Denial

Subject: Mine Ventilation Plan, Section 75.370, 30 CFR 75, Upper  
Big Branch Mine-South, I.D. No. 46-08436, Performance  
Coal Company, Montcoal, Raleigh County, West Virginia

The revision, as submitted, cannot be approved and is hereby denied. Please refer to the attached marked-up copy of the revision map and narrative, which notes the deficiencies found upon review.

# TYPICAL LONGWALL FACE VENTILATION

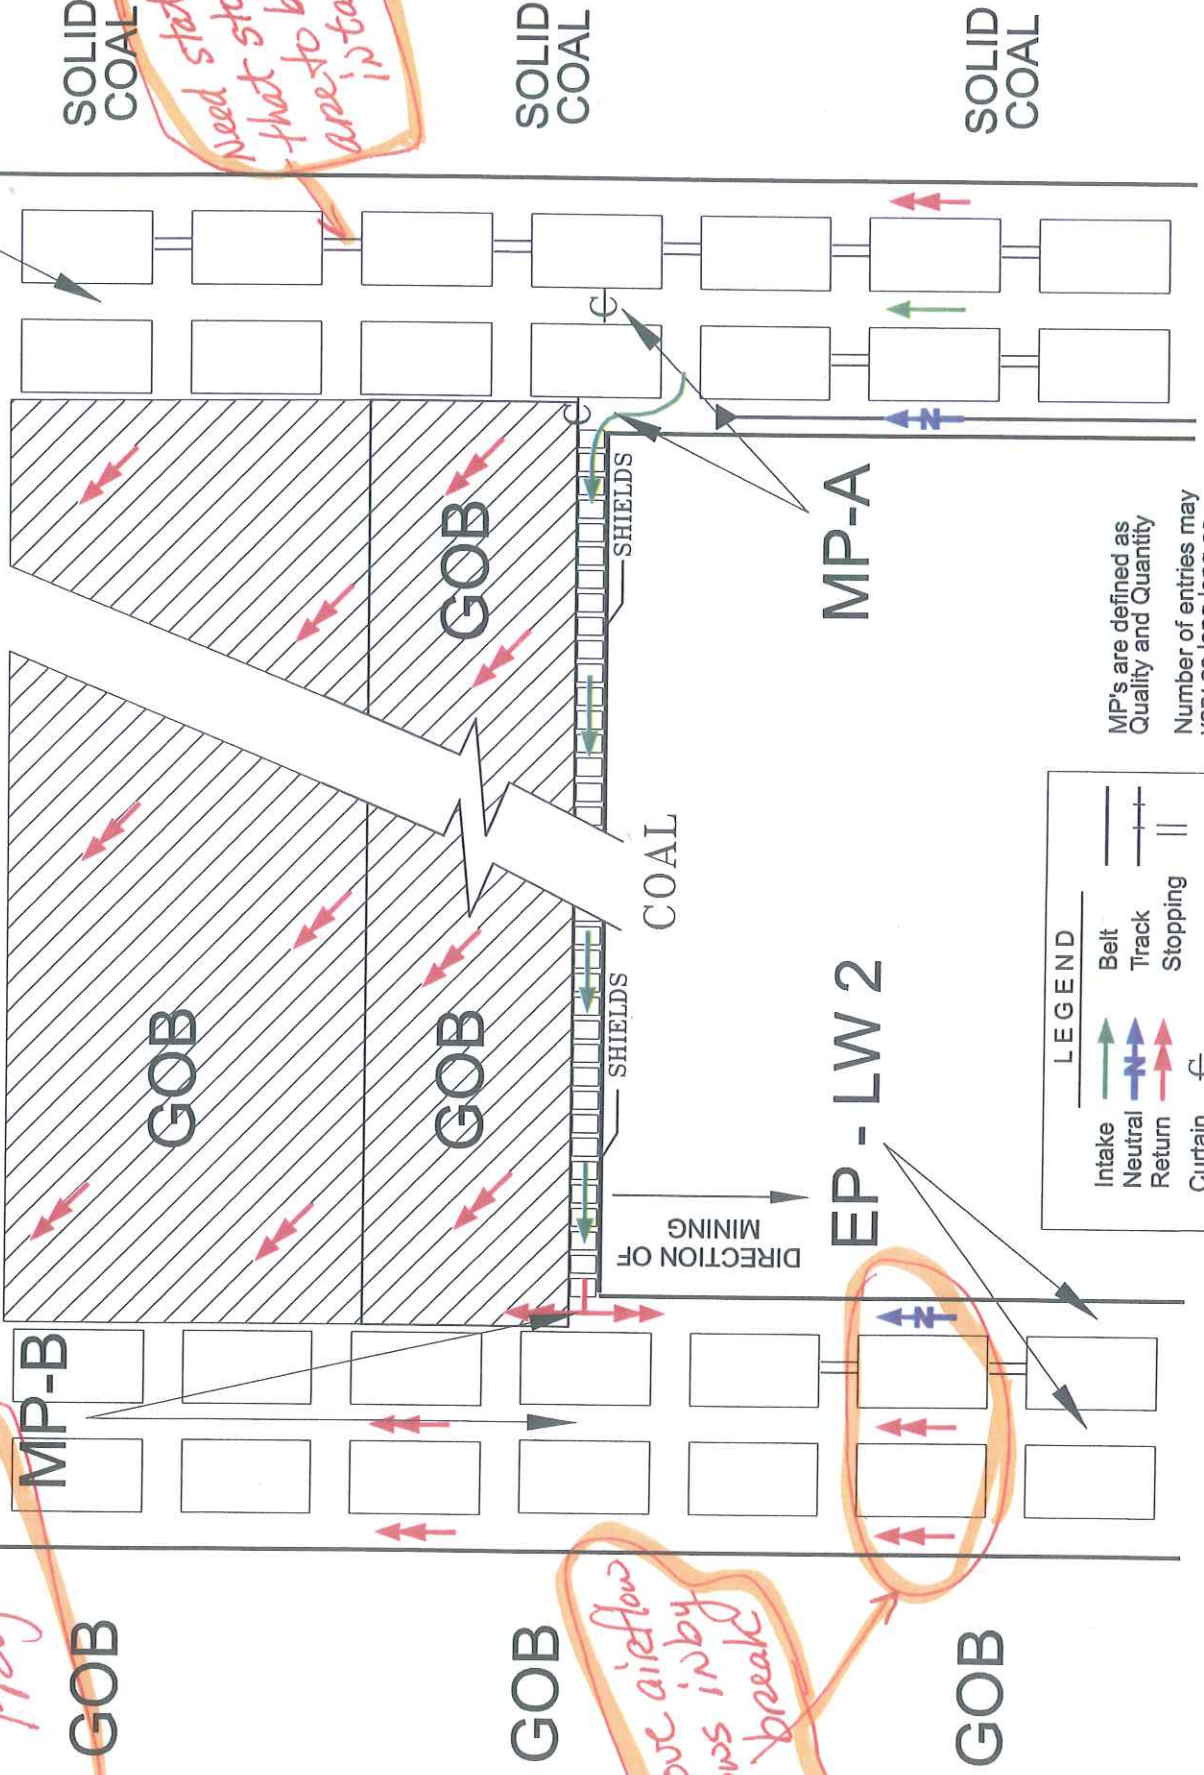
*Need statements that stopping is not to be intact*

*Is Not as Showed Projected*

*move airflow arrows in by one break*

**TYPICAL LONGWALL FACE VENTILATION**  
 Performance Coal Company  
 Upper Big Branch Mine 46-08436 (U-3042-92)

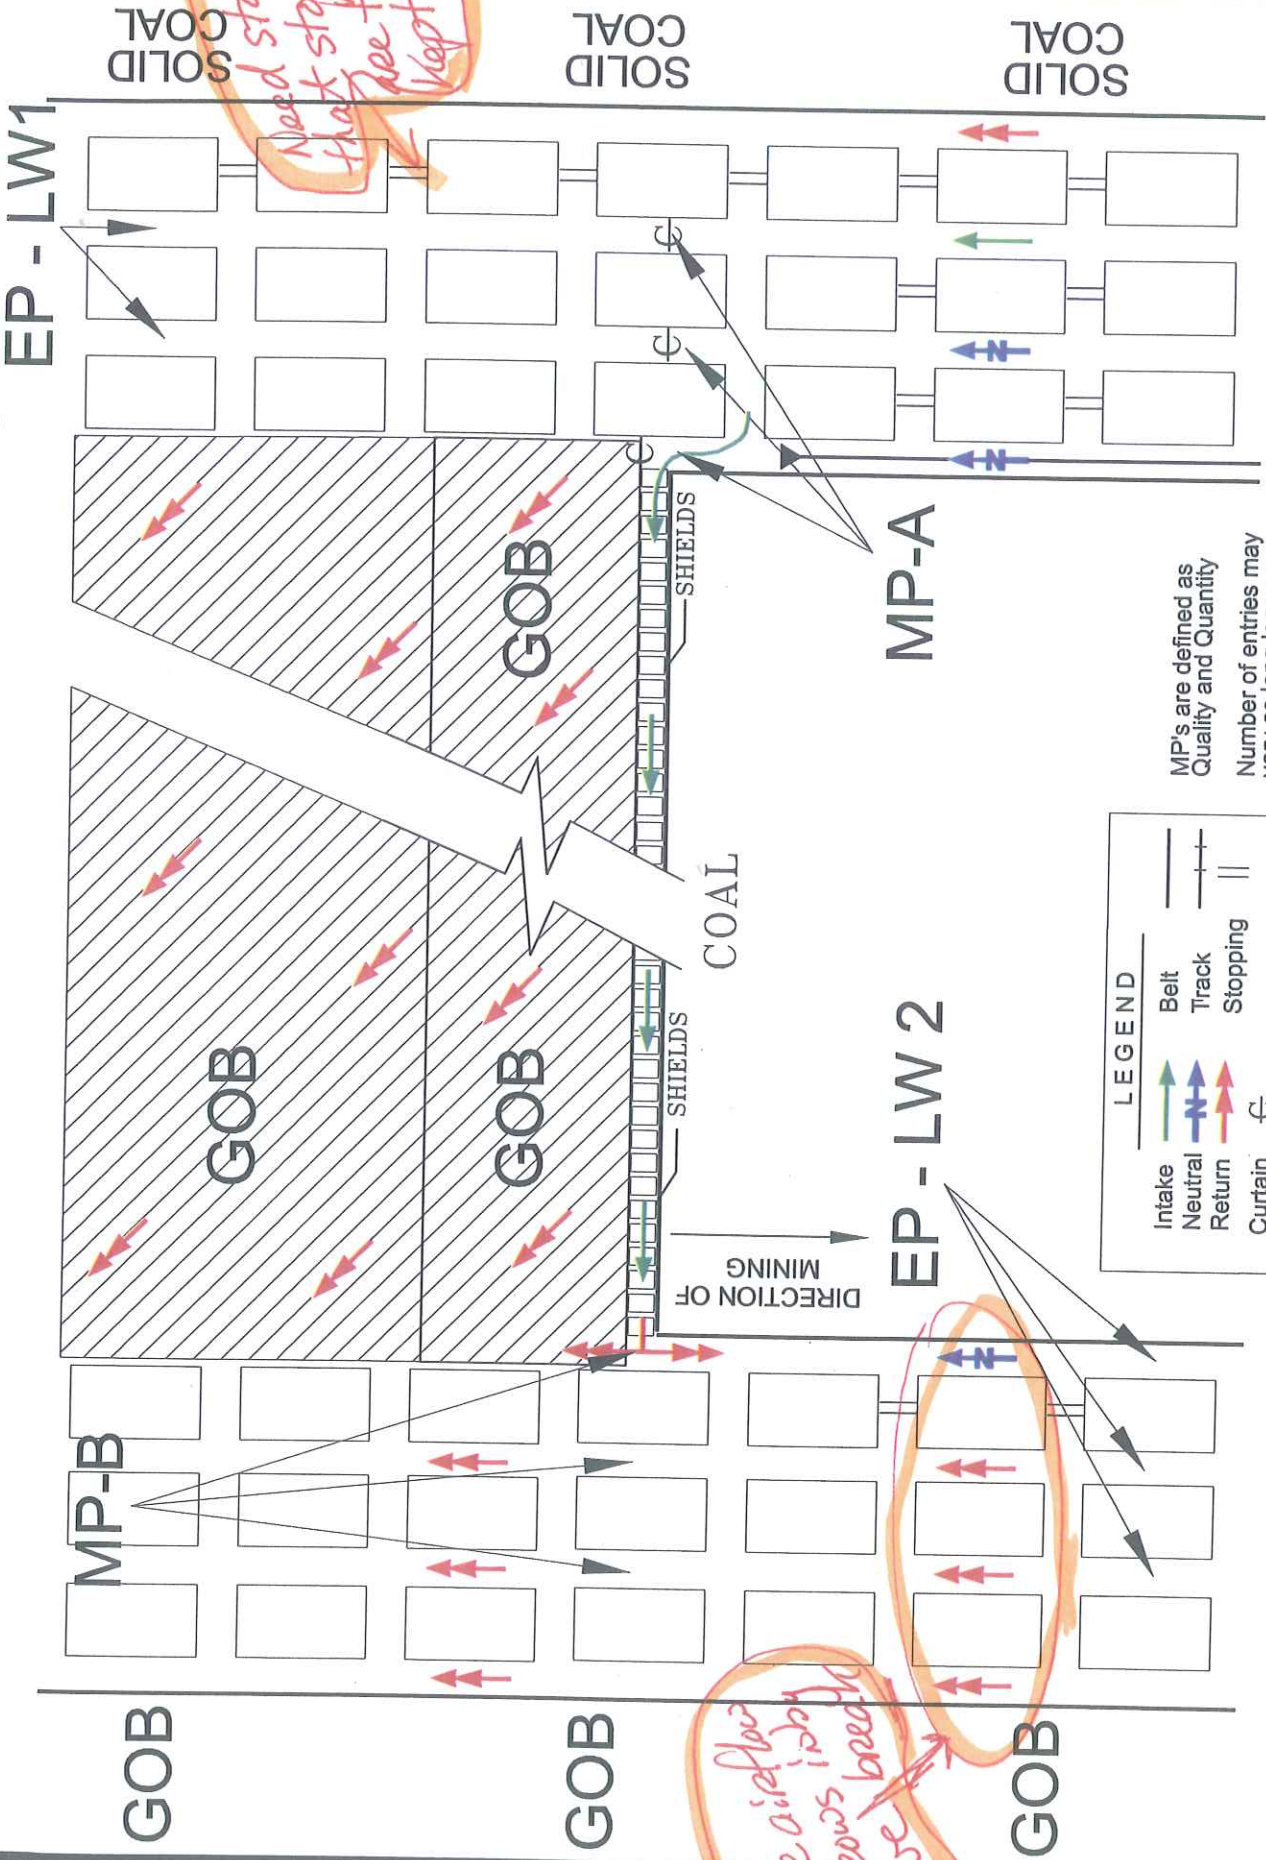
*Need menst start stopping that to be kept instead*

*Allow air to by Move air by Area's break*
